TYPICAL SECTIONS
MOANALUA FREEWAY
REPLACE GLARESCREENS AND GUARDRAILS
FEDERAL AID PROJECT NO. STP-H201(2)
INTERSTATE ROUTE H-1
REPLACE GLARESCREENS
FEDERAL AID PROJECT NO. IM-H1-1(231)
Scale: As Shown Date: Nov. 1997
SHEET No. 1 OF 3 SHEETS

STATE OF HAWAII
DEPARTMENT OF TRANSPORTATION
HIGHWAYS DIVISION
TYPICAL SECTIONS & DETAIL
CONCRETE GLARE SCREEN UPGRADE DETAILS
MOANALUA FRWY. REPLACE GLARE SCREENS & GUARDRAILS
Alaia Interchange To Moanalua Stream Bridge
F.A. Proj. No. STP-H20(2) AND
INTERSTATE ROUTE H-1 REPLACE GLARE SCREENS
Alaia Heights Drive To Salt Lake Boulevard
F.A. Proj. No. 1M-HI-1(231)
Scale: As Noted Date: Nov. 1997

STATE OF HAWAII DEPARTMENT OF TRANSPORTATION HIGHWAYS DIVISION	
TYPICAL SECTIONS & DETAIL	
WORK ZONE CONSTRUCTION PLAN	
MOANALUA FRWY. REPLACE GLARE SCREENS & GUARDRAILS Aiea Interchange To Moanalua Stream Bridge F.A. Proj. No. STP-H20(2) AND	
INTERSTATE ROUTE H-1, REPLACE GLARE SCREENS Aiea Heights Drive To Salt Lake Boulevard F.A. Proj. No. 1M-HI-1(231)	
Scale: As Noted	Date: Nov. 1997
SHEET No. 3 OF 3 SHEETS

MEDIAN BARRIER UPGRADE
AT 2" TRAFFIC LIGHT CONDUIT LOCATION
H-1 @ STA. 225+70± TO @ STA. 228+20±
Scale: 3/4" = 1'-0"

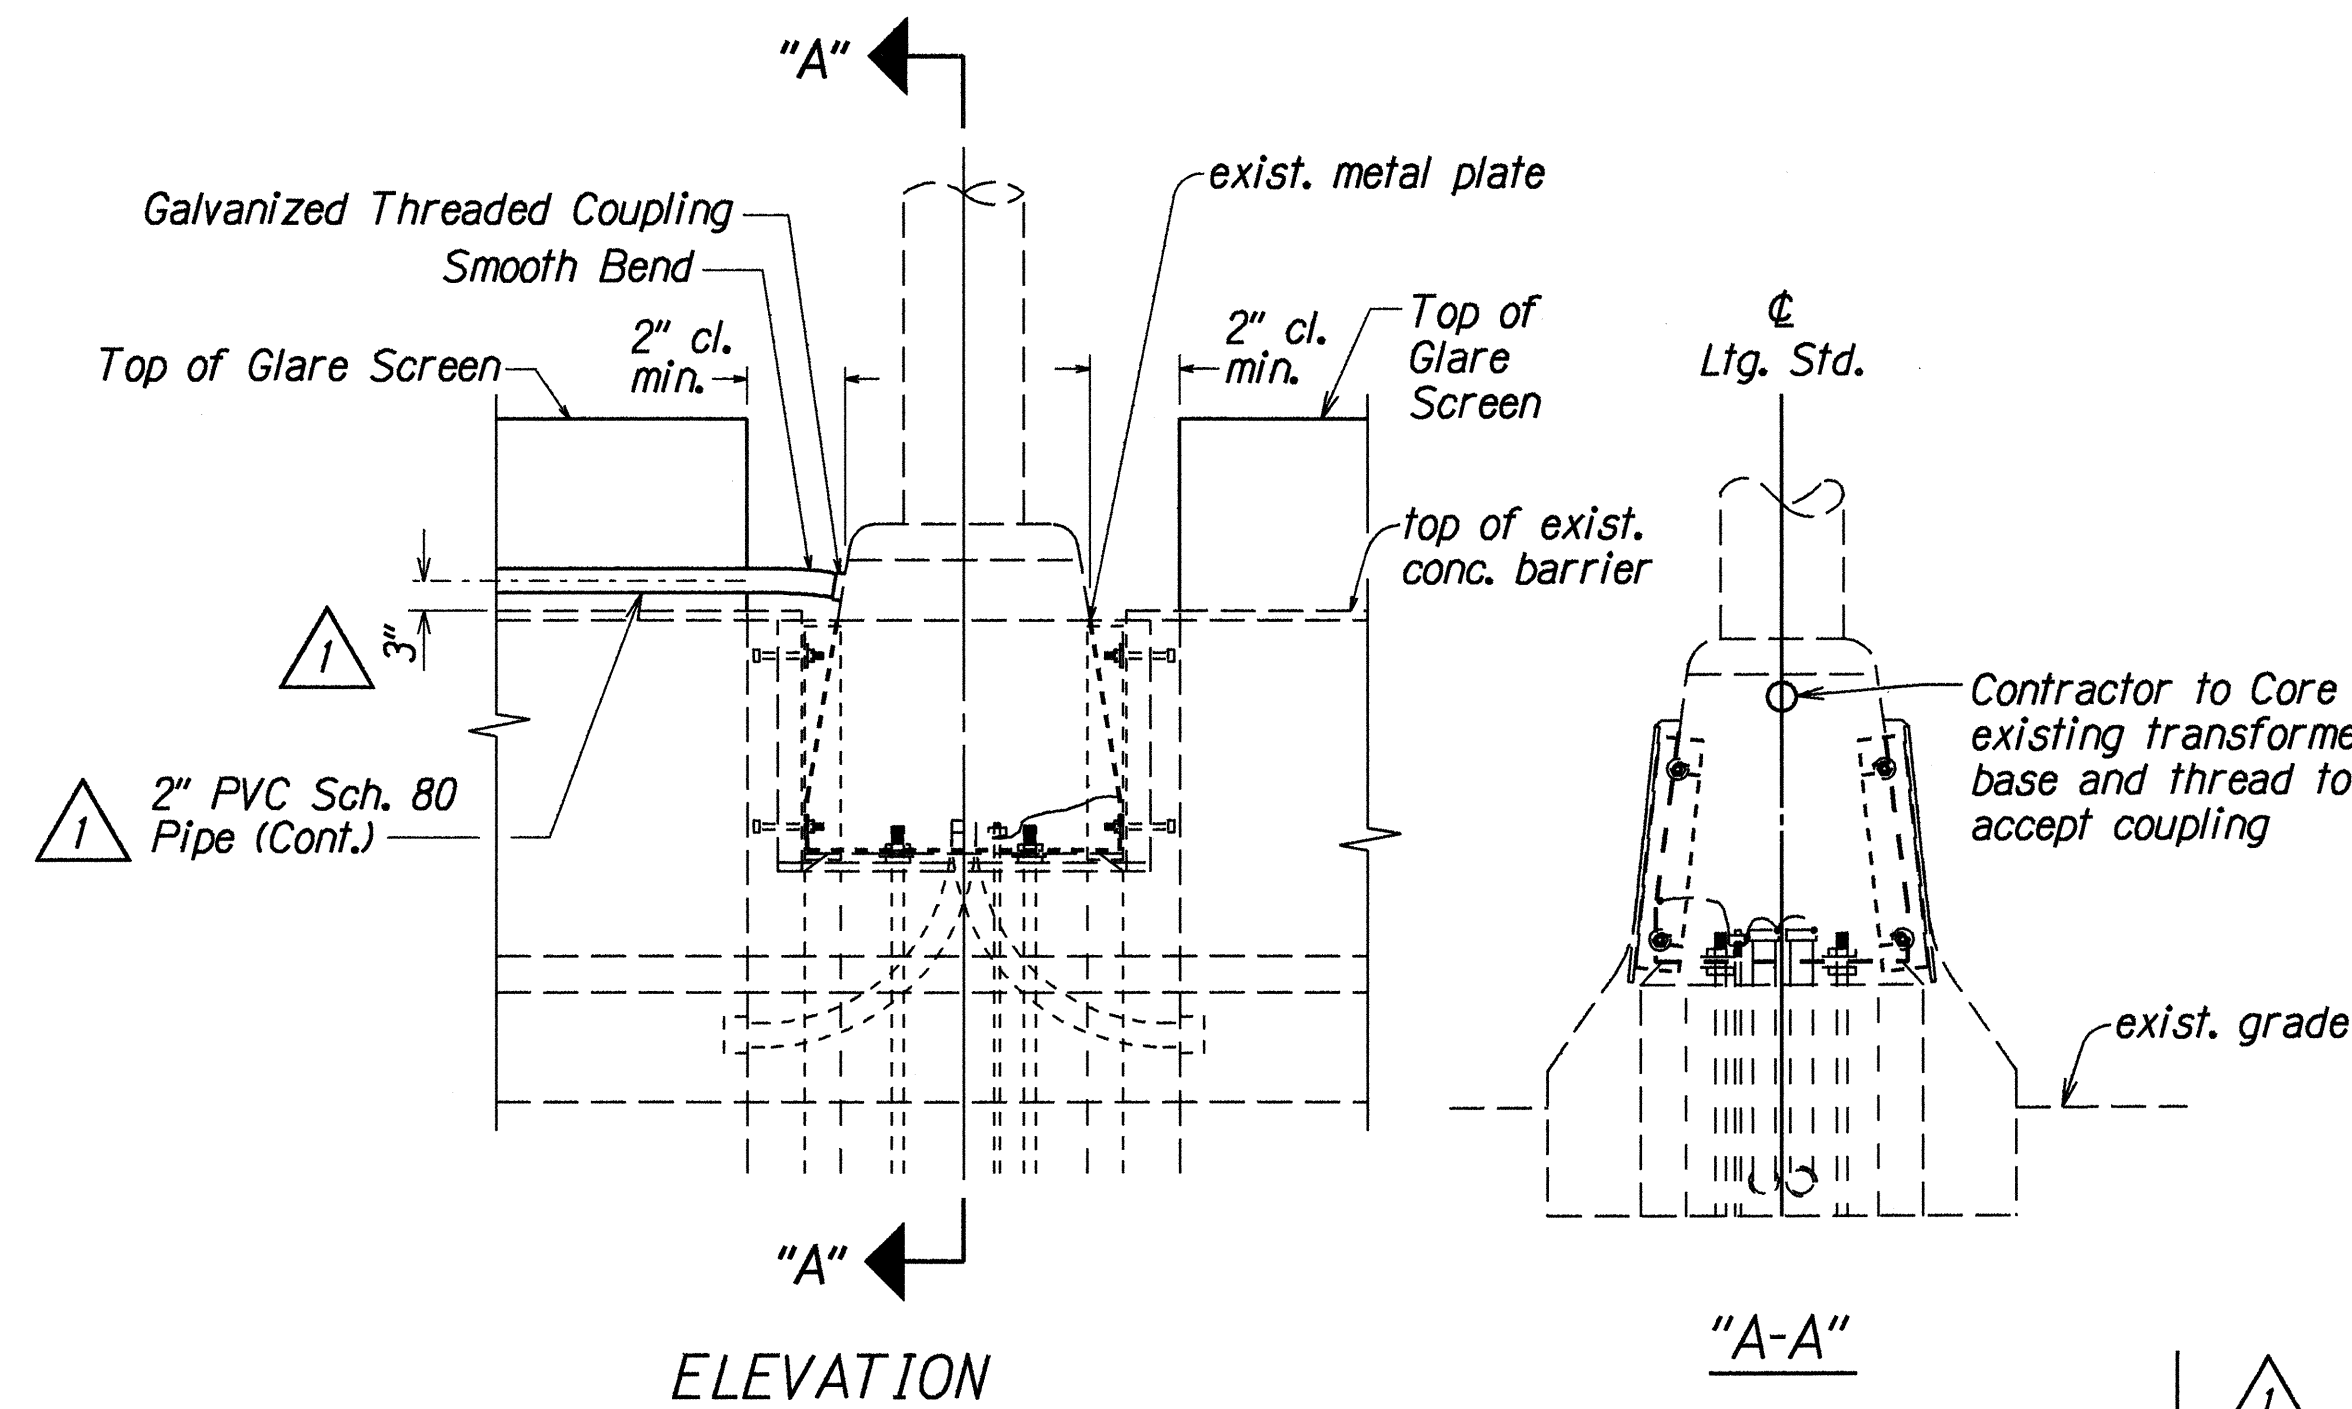
Added 2" PVC Sch. 80 Pipe and changed 2" I.D. galvanized pipe to 2" PVC Sch. 80 pipe in median barrier. Removed "T#B" from Type "A" Median Barrier Upgrade det. for 3/4" cont. chamfer E.F. Labels, dimensions, & dim. lines changed &/or moved for clarity. Added "width" to Note #9. Added PVC Plug and Expansion Coupling Sections.
